Subject: Revised Supplemental Environmental Impact Statement
for Proposed Interim Group Cesspool System, Nanakuli
Residence Lots, 4th and 5th Series and Flood Control
Channel, Nanakuli, Waianae, Oahu

FINAL

PROPOSED INTERIM GROUP

CESSPOOL SYSTEM

typical cesspool

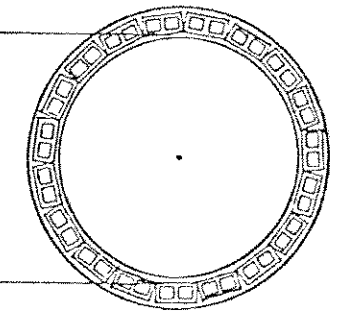
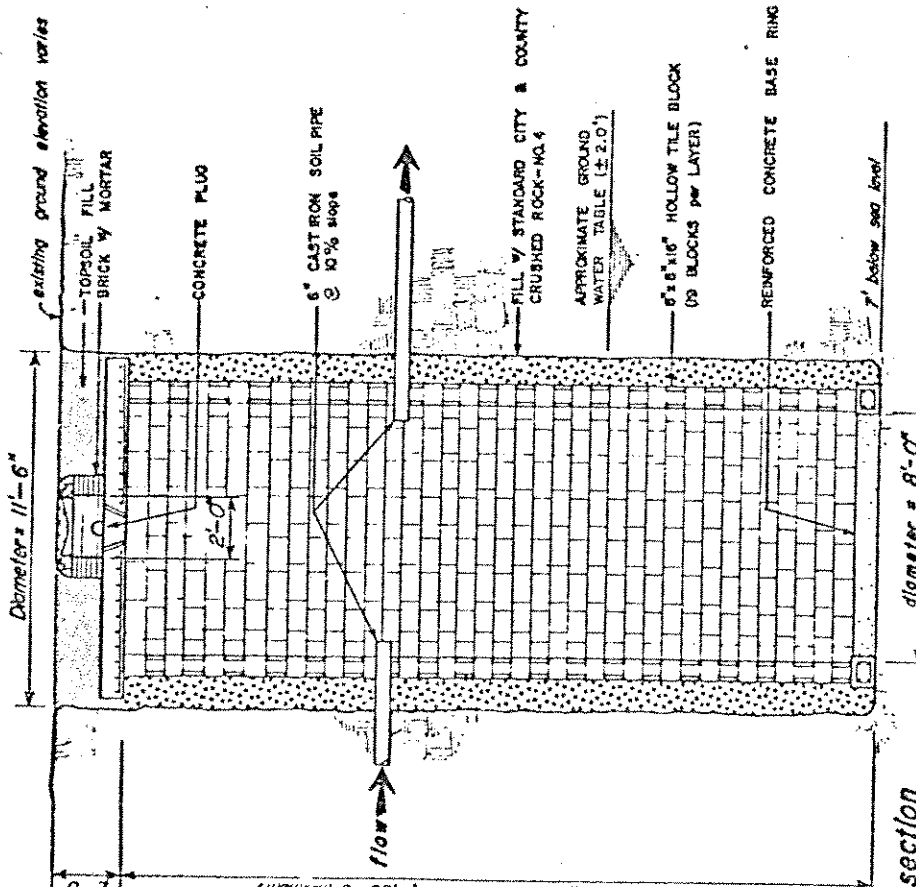
6) Page 6-8. The discussion on these pages continually refers to 8' diameter cesspools. We note, however, in figure 5 that the interior diameter is 6'6". Since the figures on pages 6 and 7 for the number of cesspools required for a given volume of waste are based on an 8' diameter cesspool it would appear that these estimates may be low by about 19%.

The interior diameter of the cesspool shown on figure 5 is 6'6", whereas the discussion refers to 8' diameter cesspools.

The interior diameter of the typical cesspool shown on figure 5 is incorrect. It should be 8 feet. The dimension has been corrected (see attached figure 5).
